UNITED STATES PATENT AND TRADEMARK OFFICE

APPLICATION NO.	FILING DATE	FIRST NAMED INVENTOR	ATTORNEY DOCKET NO.	CONFIRMATION NO.
10/575,875	02/01/2007	Patrick Lewis Blott	SMNPH.004APC	6850
20995 7590 01/23/2009 KNOBBE MARTENS OLSON & BEAR LLP 2040 MAIN STREET FOURTEENTH FLOOR IRVINE, CA 92614				
EXAMINER TREYGER, ILYA Y				
ART UNIT		PAPER NUMBER		
3761				
NOTIFICATION DATE		DELIVERY MODE		
01/23/2009		ELECTRONIC

Office Action Summary

DETAILED ACTION

FIG 1

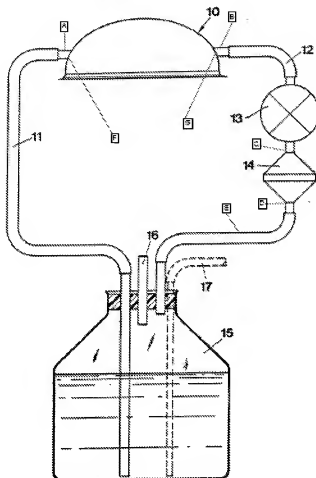
10. In Re claim 19, Swanbeck discloses a device for rinsing and treating wounds comprising: a suction cup 10 (Fig. 1) which is the wound dressing made of rubber or plastic (p. 2, ln. 33) and consequently fully capable of forming a fluid-tight seal or closure over a wound; the feed and discharge tubes (inlet and outlet pipes) A and B (Fig. 1) connected to outlet and discharge tubes 11 and 12 (p. 2, ln. 34, 35; Fig. 1); a sterilizing filter (fluid cleansing means) 14 (p. 3, ln. 33; Fig. 1) having an inlet port C (Fig. 1) connected to a fluid offtake tube 12 (Fig. 1) and an outlet port D (Fig. 1) connected to a fluid recirculation tube E (Fig. 1); a fluid reservoir 15 (Fig. 1); a peristaltic pump 13 (p. 2, ln. 37 – p. 4, ln. 1; Fig. 1) which is a device for moving fluid through the wound dressing and cleansing means; an apparatus for supplying thermal energy (p. 4, ln. 3-5). With regard to the bleeding means, it is the position of the Examiner that fluid is supplied via tube 11 from the reservoir 15 and recirculated through the device via tube 12, recirculating the fluid through the flow path.

14. In Re claim 14, Swanbeck discloses the method of treating a wound, comprising the steps of:

providing a conformable wound dressing 10 (Fig. 1) configured to form a relatively fluid-tight seal around at least a portion of a wound (p. 2, ln. 33);

the feed and discharge tubes (inlet and outlet pipes) A and B (Fig. 1) connected to outlet and discharge tubes 11 and 12 (p. 2, ln. 34, 35; Fig. 1);

pumping fluid through at least the inlet pipe, the wound dressing, and the outlet pipe (p. 2, ln. 37 – p. 4, ln. 1; Fig. 1);

cleansing the fluid that flows out of the wound dressing (p. 3, ln. 33; Fig. 1);

19. In Re claim 1, Swanbeck discloses a device for rinsing and treating wounds comprising: a suction cup 10 (Fig. 1) which is the wound dressing made of rubber or plastic (p. 2, ln. 33) and consequently fully capable of forming a fluid-tight seal or closure over a wound; the feed and discharge tubes (inlet and outlet pipes) A and B (Fig. 1) connected to outlet and discharge tubes 11 and 12 (p. 2, ln. 34, 35; Fig. 1); a sterilizing filter (fluid cleansing means) 14 (p. 3, ln.

33; Fig. 1) having an inlet port C (Fig. 1) connected to a fluid offtake tube 12 (Fig. 1) and an outlet port D (Fig. 1) connected to a fluid recirculation tube E (Fig. 1); a fluid reservoir 15 (Fig. 1); a peristaltic pump 13 (p. 2, ln. 37 – p. 4, ln. 1; Fig. 1) which is a device for moving fluid through the wound dressing and cleansing means; an apparatus for supplying thermal energy (p. 4, ln. 3-5). With regard to the bleeding means, it is the position of the Examiner that fluid is supplied via tube 11 from the reservoir 15 and recirculated through the device via tube 12, recirculating the fluid through the flow path.

23. In Re claim 5, Swanbeck discloses the apparatus comprising a sterilizing filter 14 (p. 3, ln. 33; Fig. 1) which is an equivalent of a single-phase cleansing system.
